### Varying coding of the electronic connection of the actuator of the turbocharger

**Vehicle Manufacturer:** BMW

**Engine code:** N47 D20C

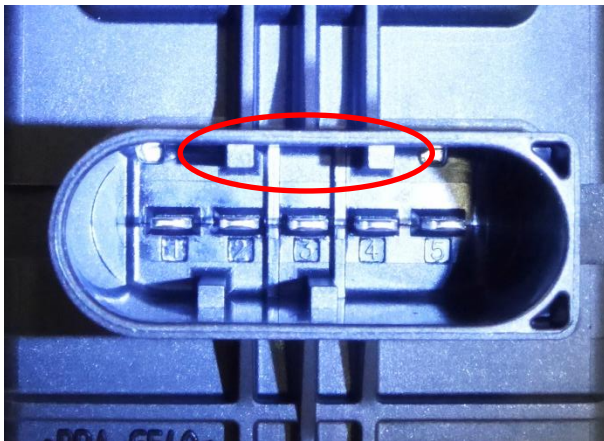
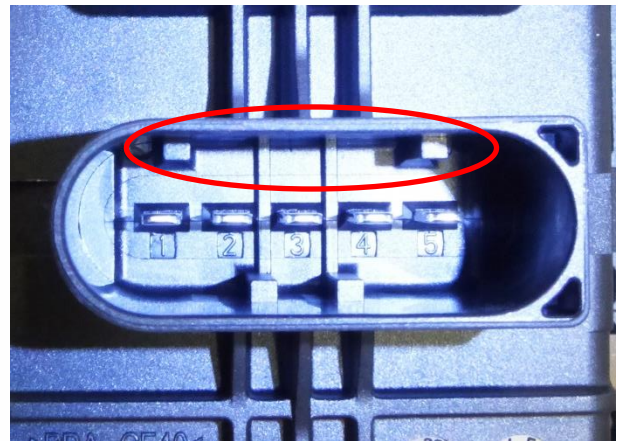
During the transition period of the change in models, the vehicle manufacturer has carried out a modification of the electronic boost pressure control of the turbocharger. The system was changed from REA (rotary electronic actuator) to SREA (simple rotary electronic actuator).

To distinguish between different versions of the turbocharger, the coding of the electronic connection to the Turbocharger as well as of the connection to the vehicle has been altered.

T915577 (Image 49335-00585) REA

T916370 (Image 49335-00644) SREA

Before installing the turbo, please check if the plug connection to the vehicle fits – if not, it's the wrong unit. The check has to be made before filling the turbo with the initial filling oil additive.
